ADDENDUM NO. 2

FLAT ROCK PUMP STATION REPLACEMENT

OCONEE JOINT REGIONAL SEWER AUTHORITY

KCI Project No. 962205803

FORCE MAIN CONNECTION DETAIL

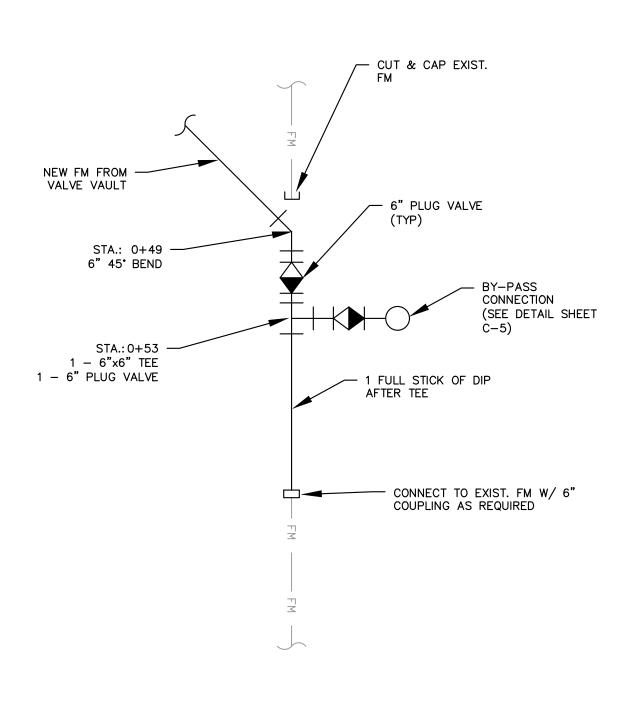
1. Sheet C-1 (Pump Station Site Plan)

A. Replace the Force Main Connection Detail with the revised detail attached with this Addendum.
